BLM Solar Energy Development Draft Programmatic EIS Comments  
9700 South Cass Avenue – EVS/240  
Argonne IL 60439

RE: Comments to Draft Programmatic Environmental Impact Statement for Solar Energy Development in Six Southwestern States

Re: Comments on Draft Programmatic Environmental Impact Statement  
for Solar Energy Development in Six Southwestern States

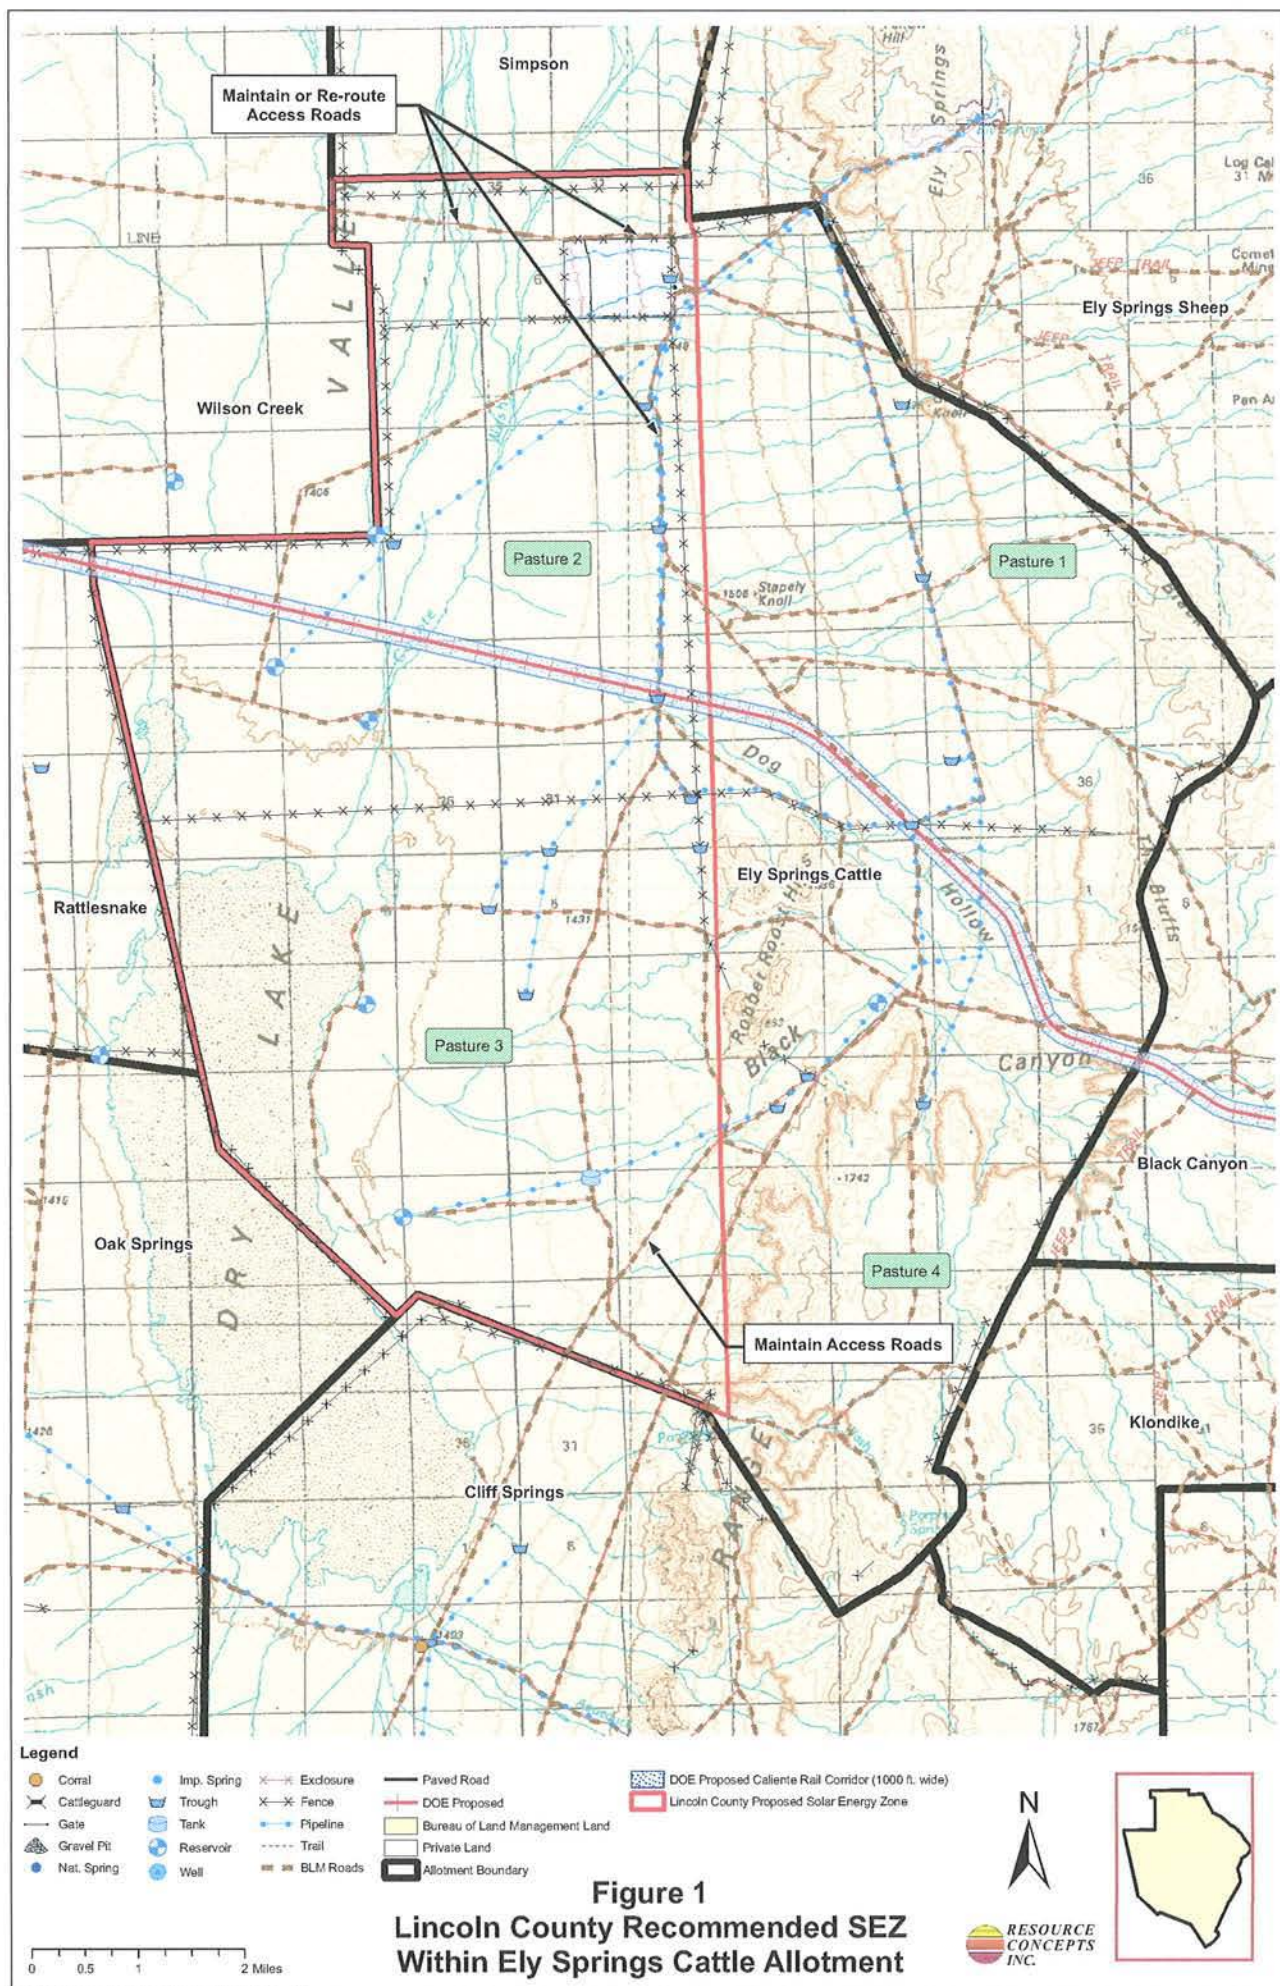
As shown on Figure 1, Lincoln County has identified an area within the Ely Springs Cattle Allotment portion of the Dry Lake Valley North SEZ. This above-mentioned area exceeds the 10,000-acre required maximum area per reasonably foreseeable transmission capacity. Therefore, designating the Delamar Valley SEZ as "lands excluded from utility-scale solar energy development" should have no impact on the overall feasibility of solar energy production within Lincoln County, nor should it encumber the renewable energy goals of the State of Nevada or the current Federal Administration based on the need for renewable energy and available transmission capacity.

# Greater Sage Grouse Areas of Concern in Nevada

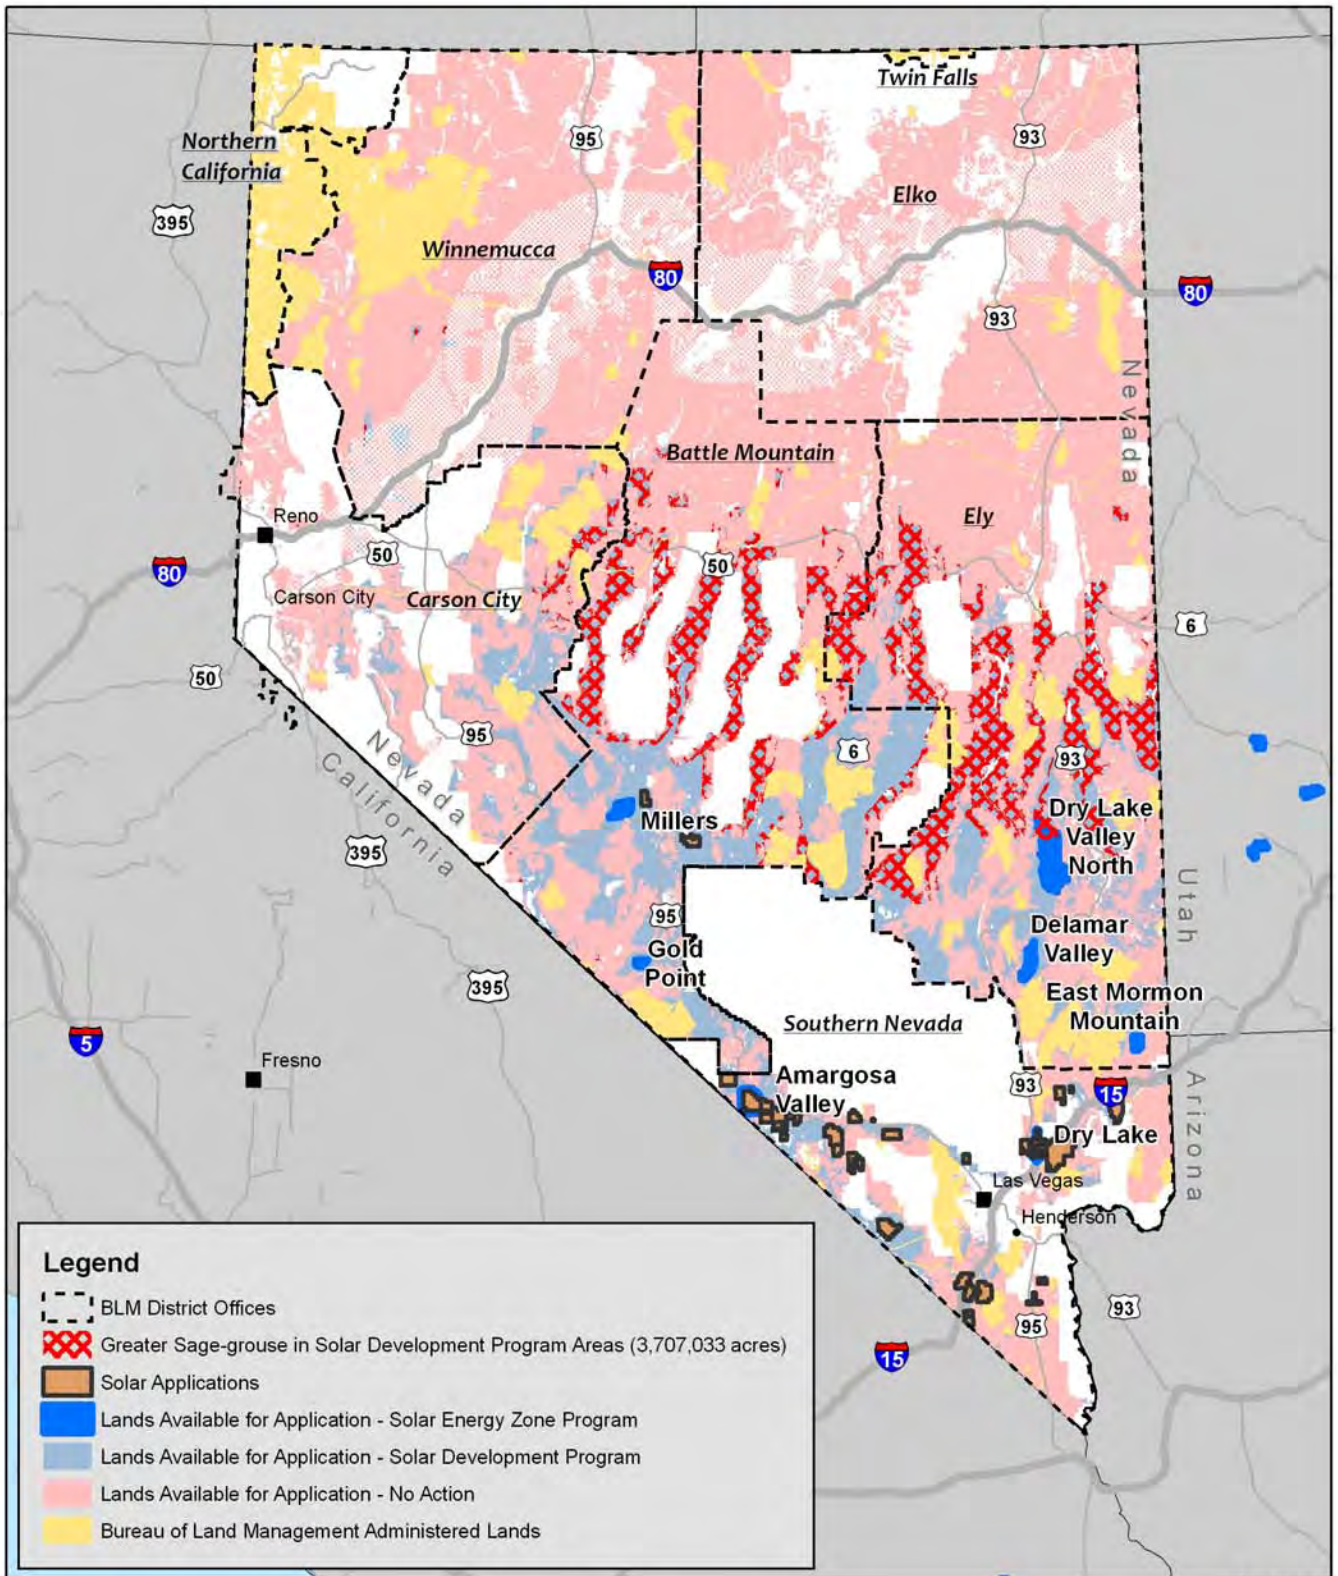
The lands in red are proposed for exclusion from solar energy development by the USFWS and are in addition to those the BLM has identified as excluded in the DPEIS.

# Greater Sage-Grouse Areas of Concern in Utah

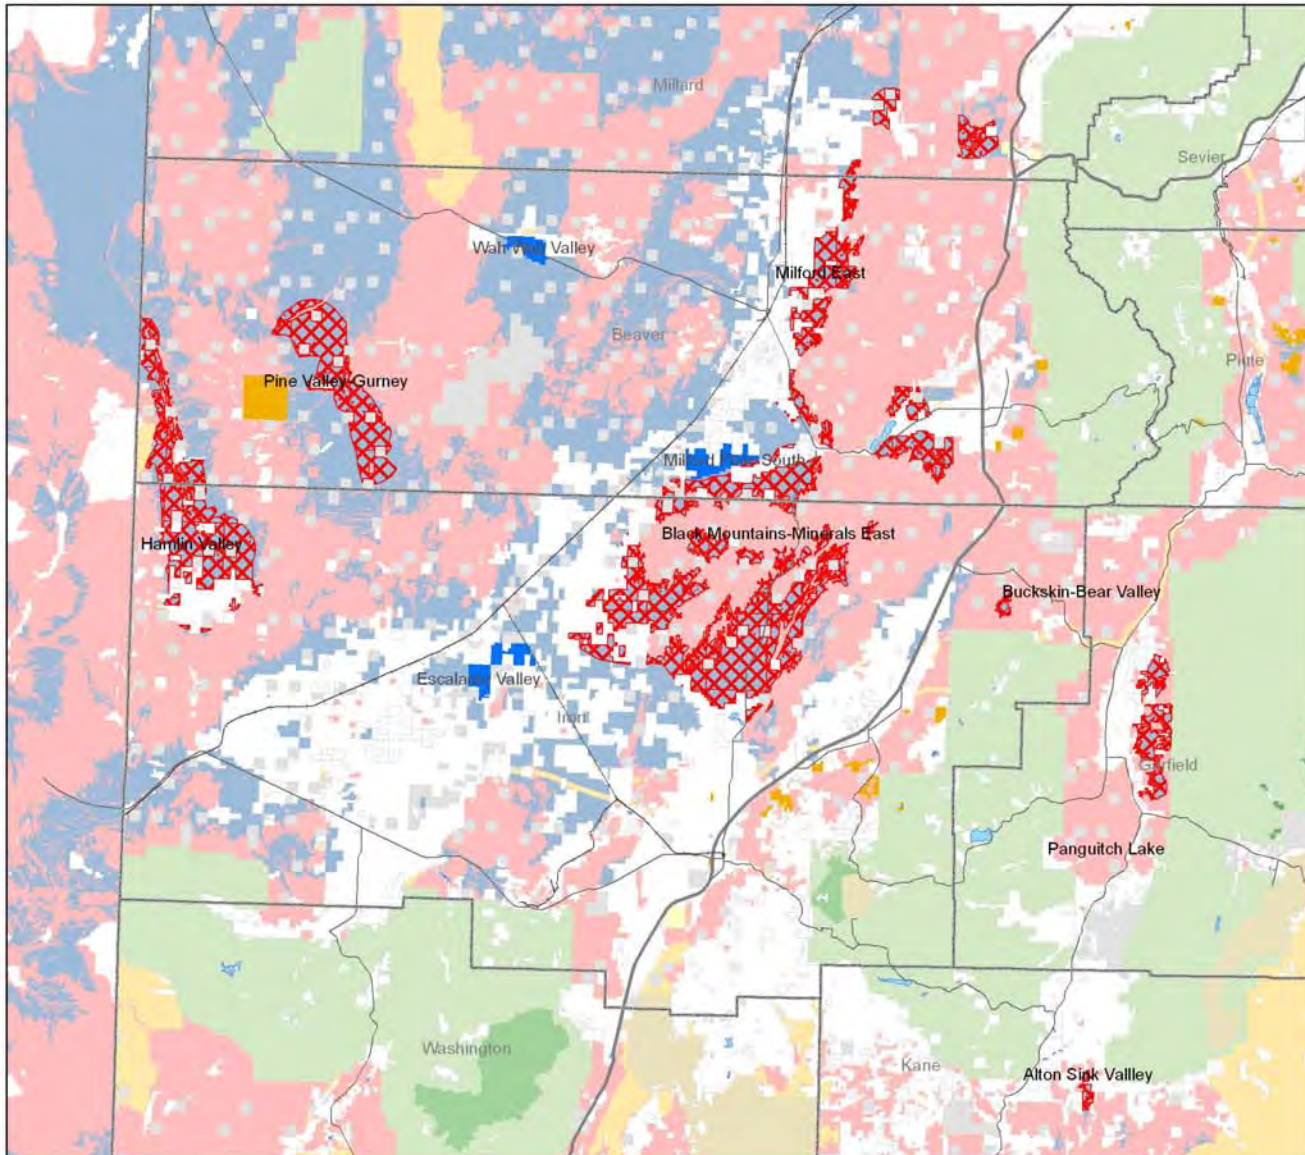
Greater sage-grouse areas of concern identified by FWS Utah Ecological Services Field Office for BLM Solar Energy Development Programmatic EIS. These crucial brood-rearing and/or wintering habitats lie within BLM's preferred alternative for solar development.

# Greater Sage-Grouse Areas of Concern in Utah

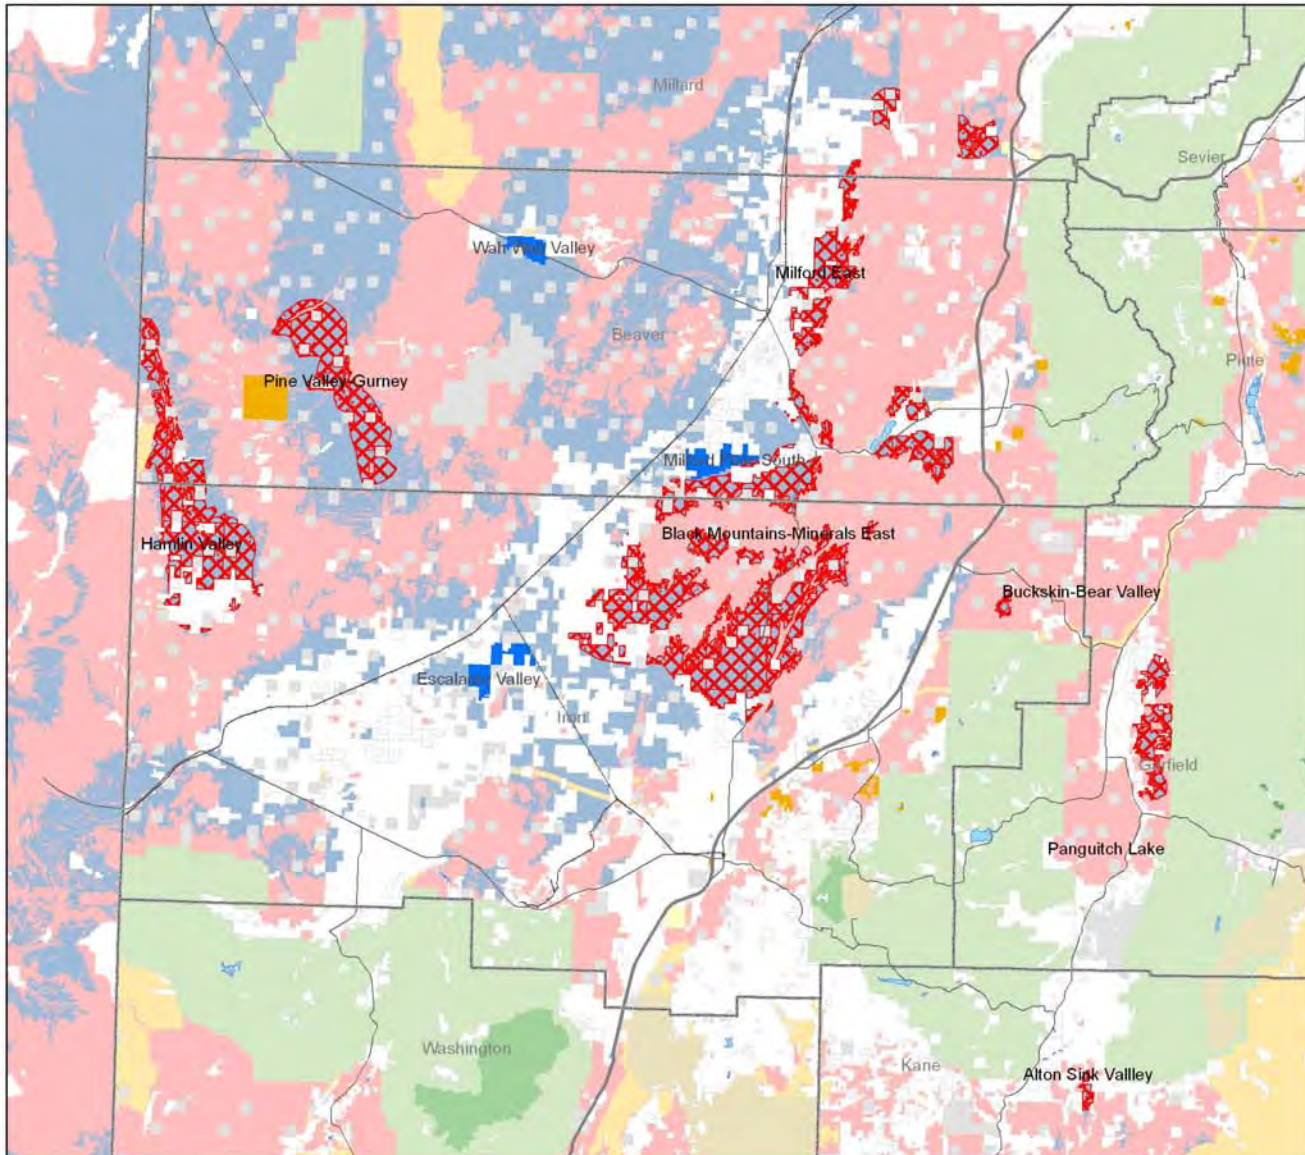
Greater sage-grouse areas of concern identified by FWS Utah Ecological Services Field Office for BLM Solar Energy Development Programmatic EIS. These crucial brood-rearing and/or wintering habitats lie within BLM's preferred alternative for solar development.
